PROJECT NO. 20123
HOSSACK & ASSOCIATES ARCHITECTS

ADDENDUM NO. 4

Issued March 26, 2021

RE: Prueter Public School – HVAC Upgrades
Kitchener, Ontario

LOUVER INFILL DETAILS

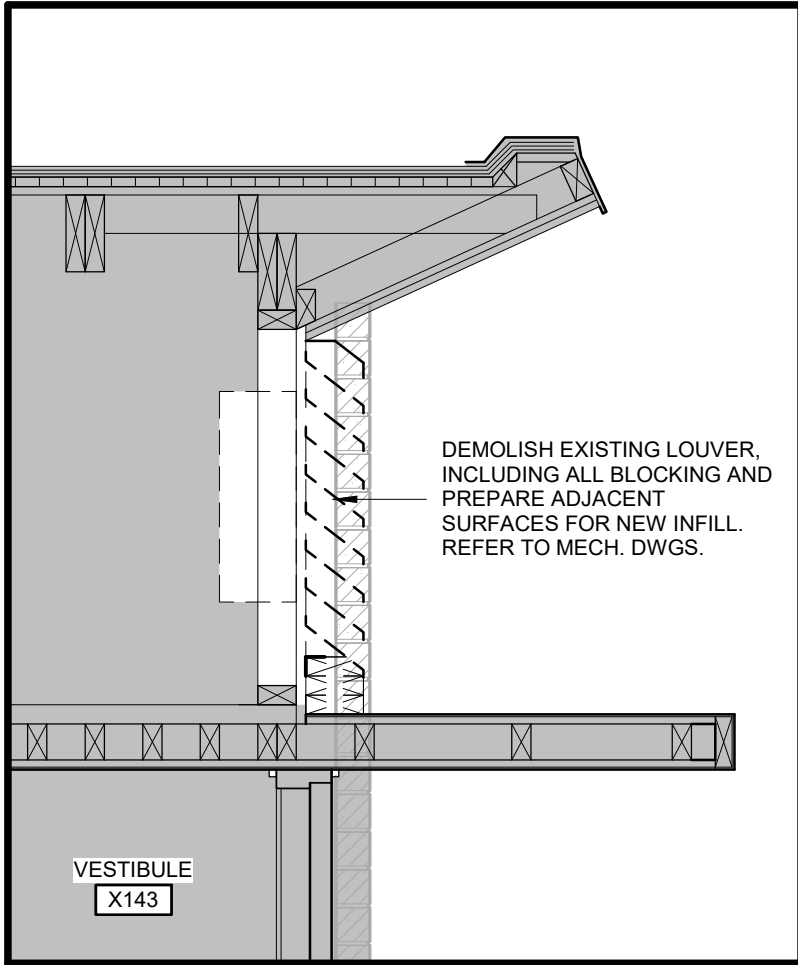
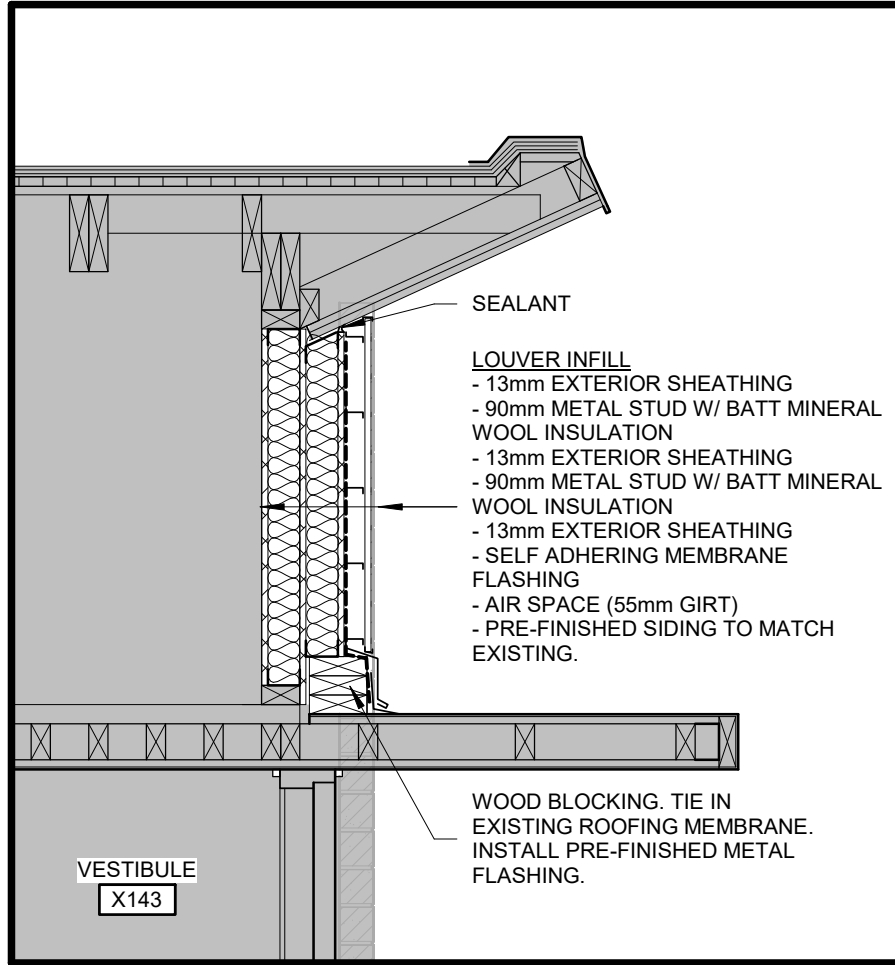
1. ADD note drawing 36/A06 to wall at left side of main entrance doors to read:
"Coordinate new opening with location of ex. date stone. Remove stone and masonry below as required to reinstall below new windows. Infill above as required with salvaged brick."
2. ADD section detail 47/A06, refer to attached drawing 1/SKA1
3. ADD section detail 48/A06, refer to attached drawing 2/SKA1

RENOVATION PLANS - HEATING & VENTILATION

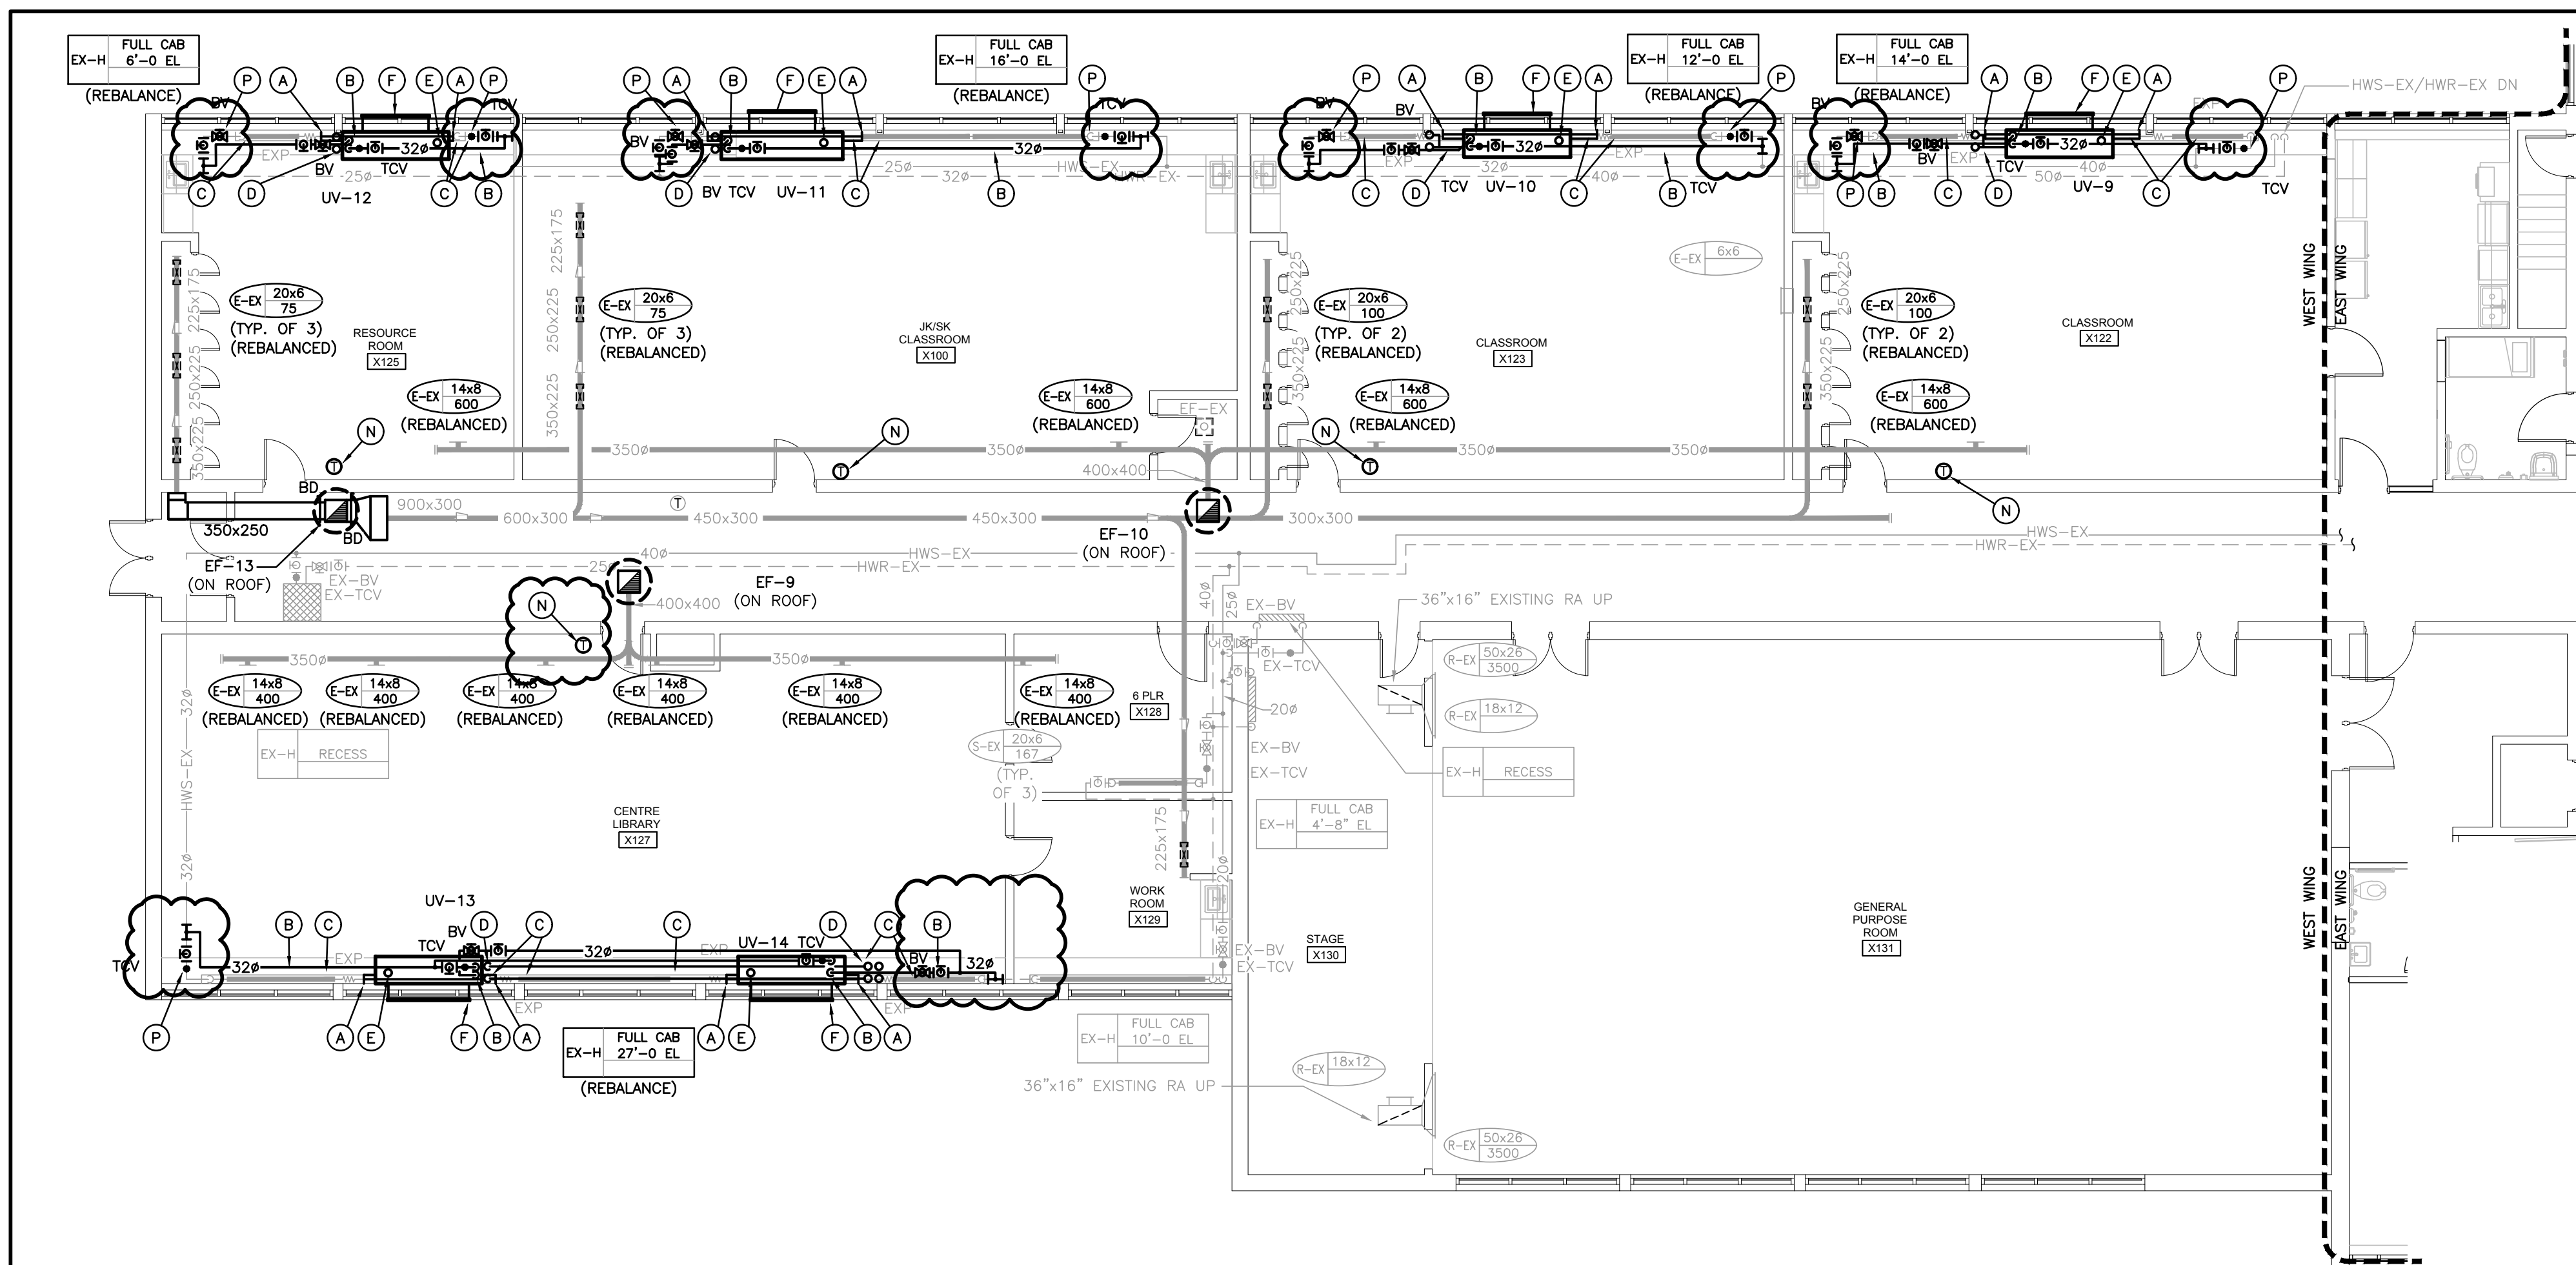
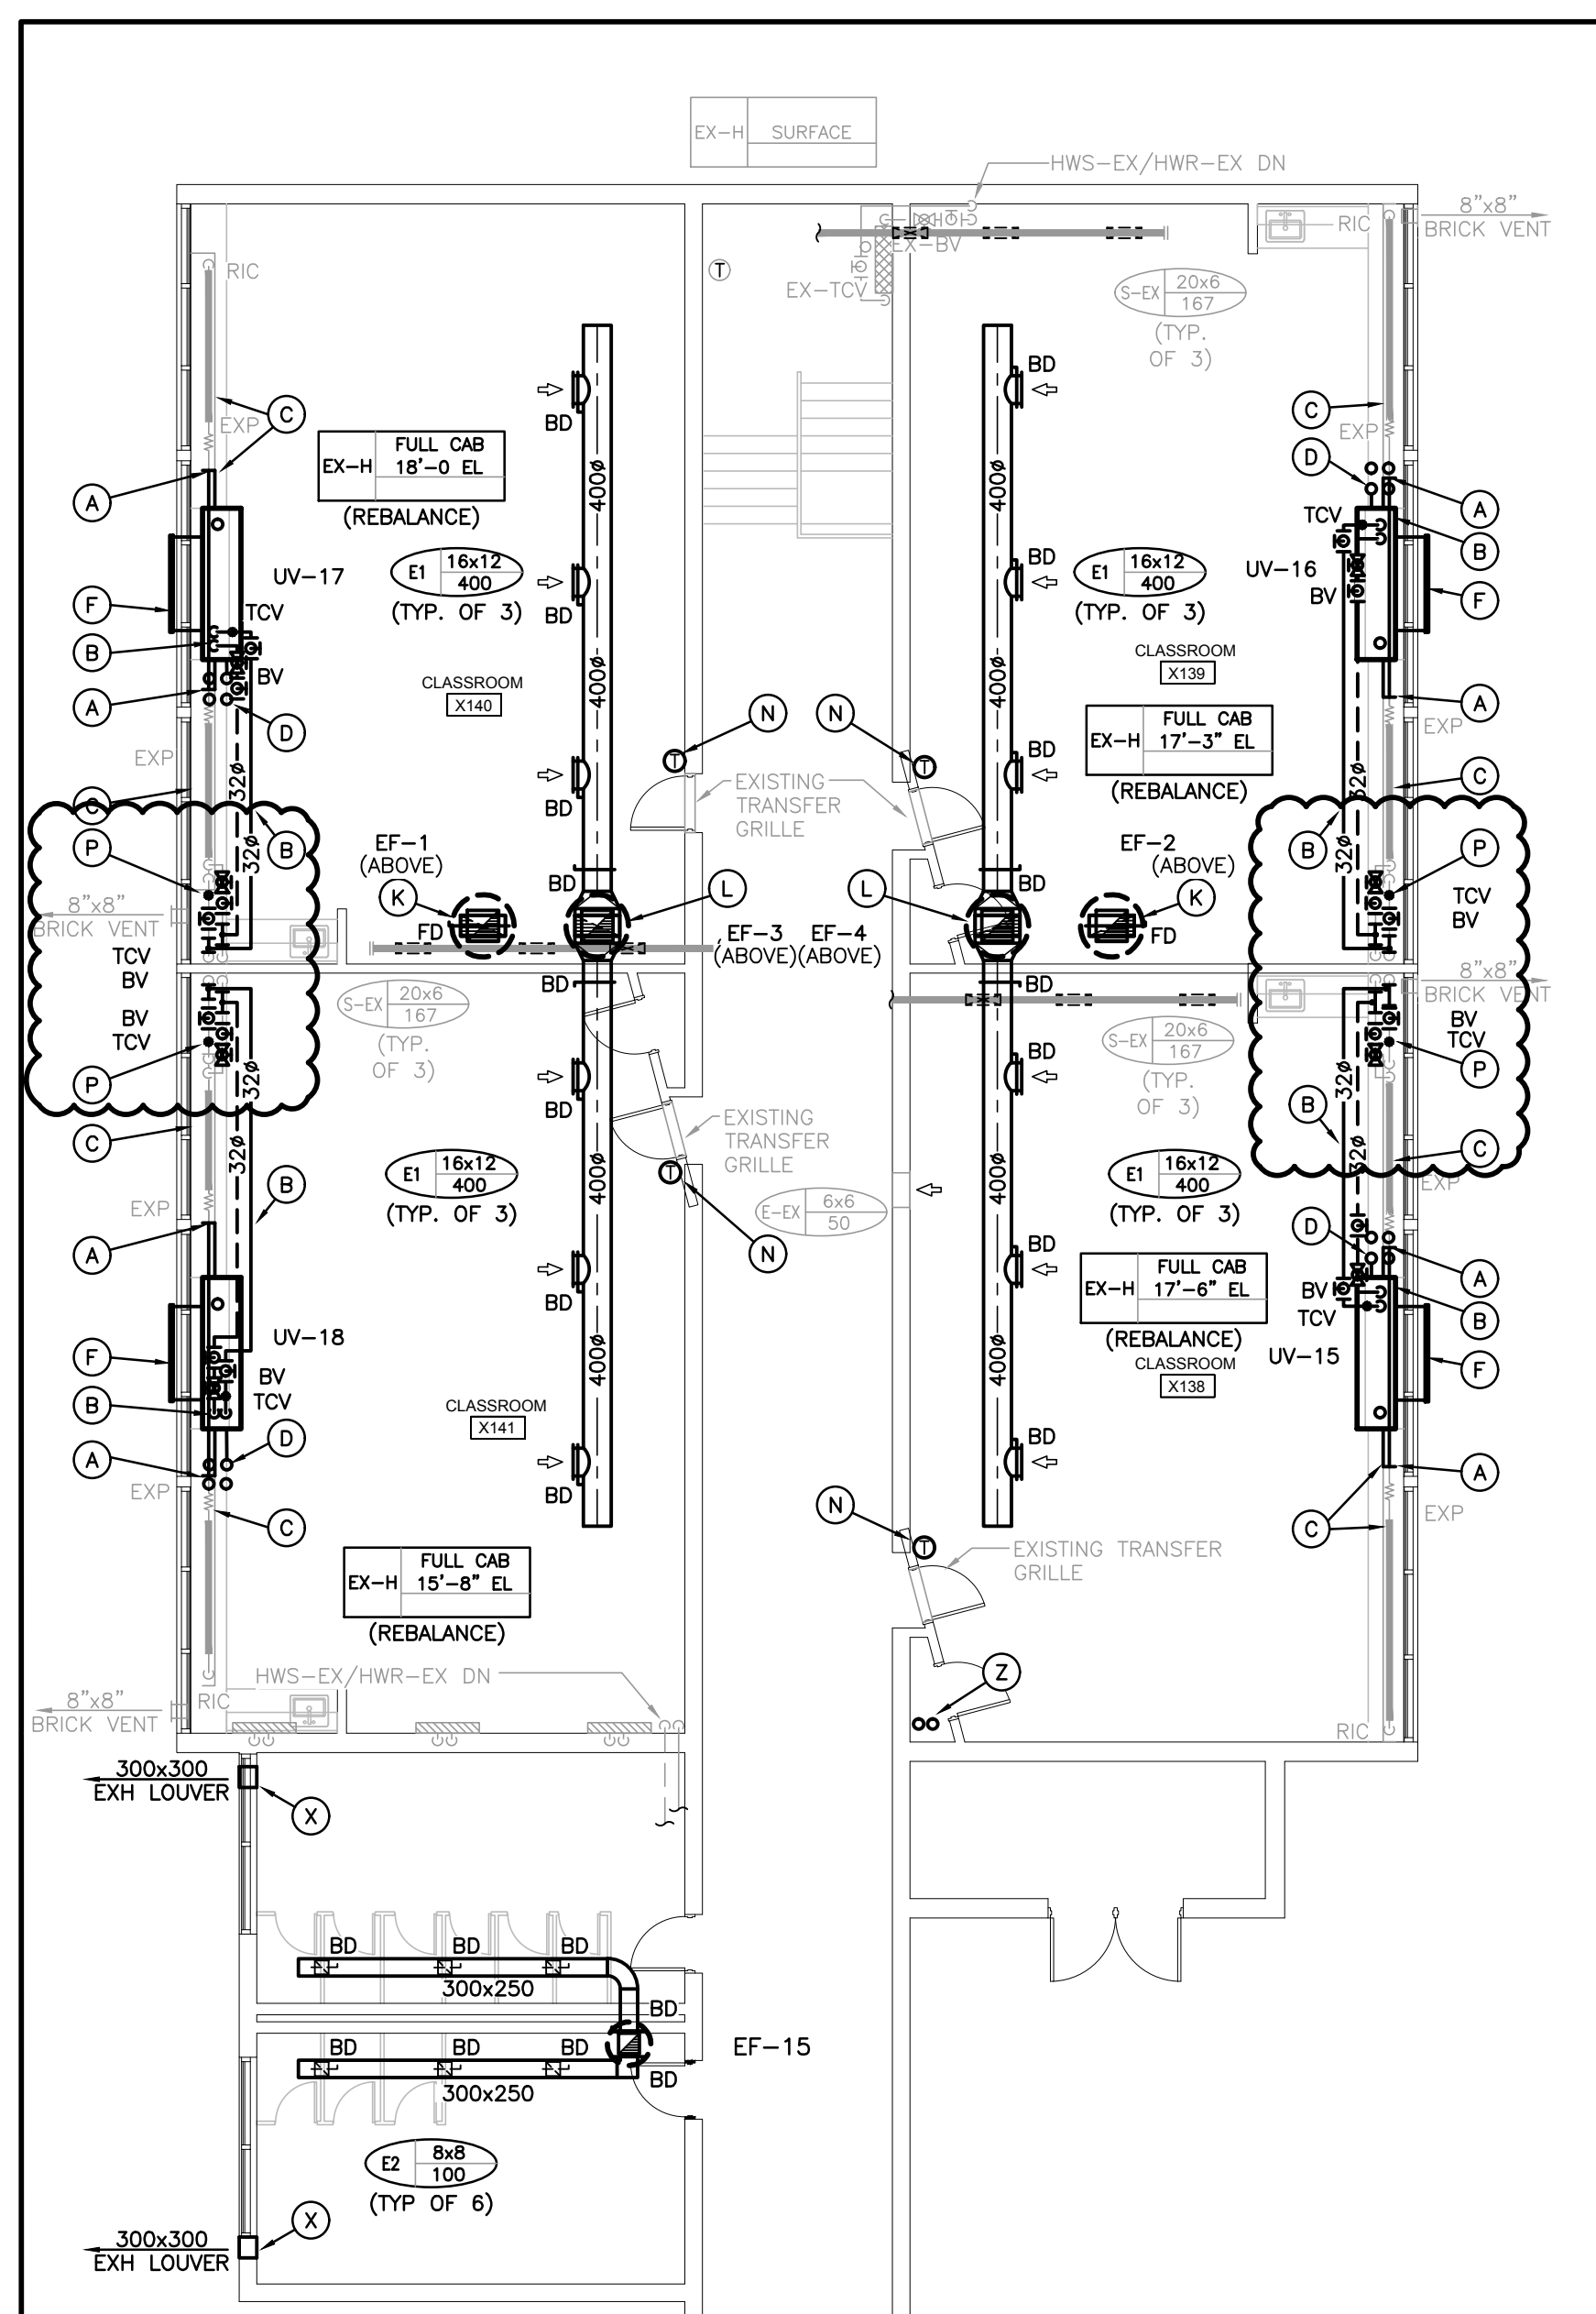
Item 6**6.0 Reference Attached Re-Issued Drawing M06**

- .1 Specific Renovation Notes have been revised. Refer to re-issued drawing M06.
- .2 Provide steel stand to be for UV-1 and UV-4 to suit exterior grade change. Louver to be located at high level in classroom. Refer to re-issued drawing M06.

- .3 Single thermostat added in Library X127 serving UV-13 and UV-14 and radiant heat. Refer to re-issued drawing M06.
- .4 Replace all existing shutoff and balancing valves serving all modified radiant heaters throughout. Refer to re-issued drawing M06.

- .5 Rebalance exhaust grilles in JK/SK X108, Boys WR 119, Girls WR X118, UTR X121 to suit new fans. Refer to re-issued drawing M06.
- .6 Thermostat in Meeting Room A105 relocated. Refer to re-issued drawing M06.

- .7 Return air grilles added in Health Room A101, Principal Office X105, Copy Area A104, Seminar Room A107, Main Office A100, and Meeting Room A105. Refer to re-issued drawing M06.

- .8 VVT and ductwork sizing has been revised. Refer to re-issued drawing M06.
- .9 250x150 duct up thru millwork from RH-1 and RH-2. Transition in ceiling space to 200Ø.

- .10 Provide acoustic insulation on new ductwork leading into EF-8, EF-11, and EF-12. Refer to re-issued drawing M06.
- .11 Run wiring for new thermostats in wire mold to the ceiling and then from ceiling to new unit ventilators and existing radiation units. Refer to re-issued drawing M06.

- .12 H3 units added in Staff Washroom A102, A103 and A108. Refer to re-issued drawing M06.
